#### Re: RIWP Amendment Letter

Former El Puente Site 98, 100, and 104 South 4<sup>th</sup> Street Brooklyn, NY Brownfield Cleanup Program Site ID No. C224260

## **Proposed Soil Boring/GW Well Location** Map

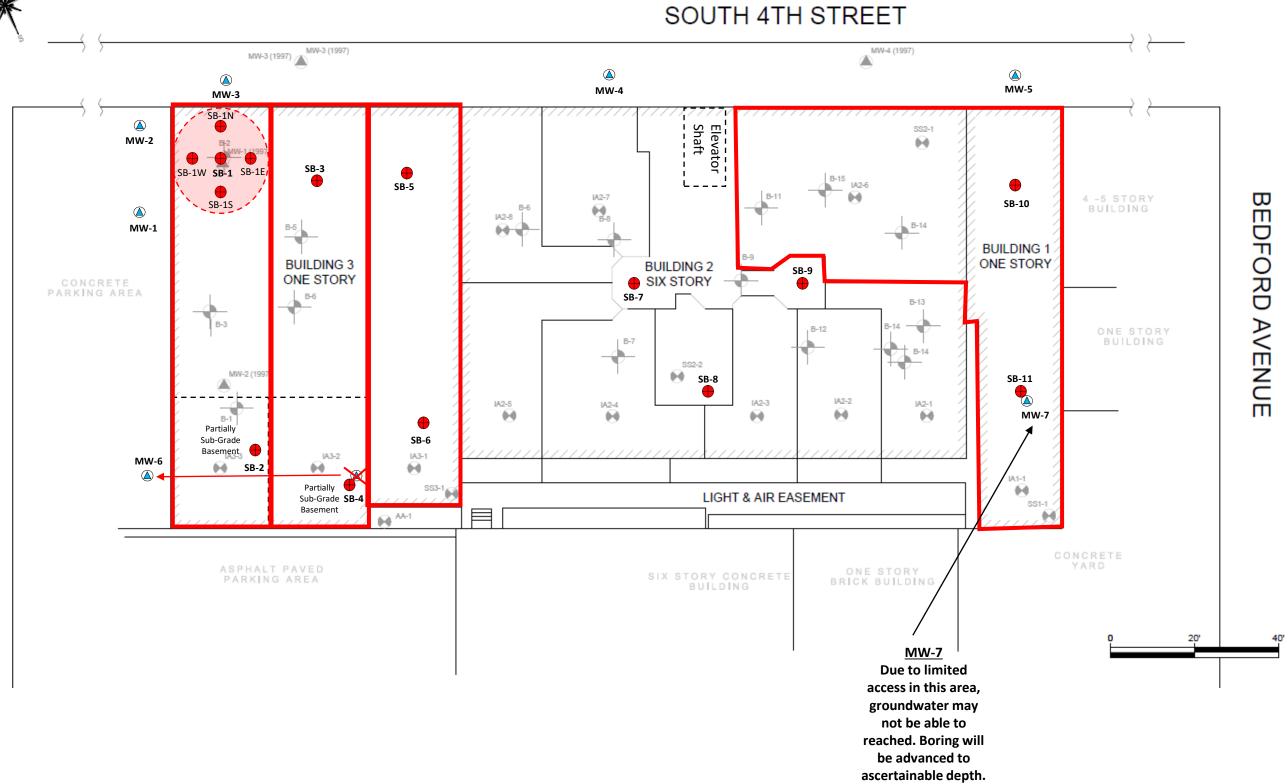
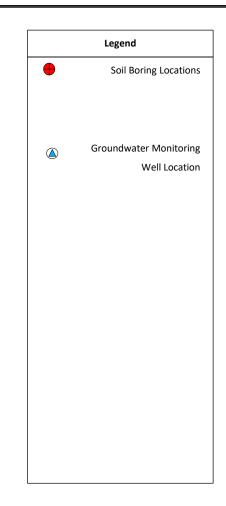
- 1. Monitoring well MW-6 shall be relocated to the southeast corner of the westerly adjoining parking lot (96 South 4<sup>th</sup> Street).
- 2. IEC will attempt to install monitoring well MW-7, but due to the access restrictions in this area, shall only advance the associated soil boring to the depth ascertainable by the drilling apparatus.
- 3. All proposed interior soil borings shall be advanced to the depths ascertainable by the proposed drilling apparatus, estimated 20-25 feet below grade, and not to the expected soil/groundwater interface. Soil samples will be collected from three (3) depth intervals, based on the terminal depth of each soil boring.

Please see Plate 1 – Proposed Soil Boring/GW Well Location Map for proposed amendments to the RIWP.

Soil samples will be collected from three depth intervals determined by the terminal depth of each soil boring.

Maximum depth expected to be 25-feet.
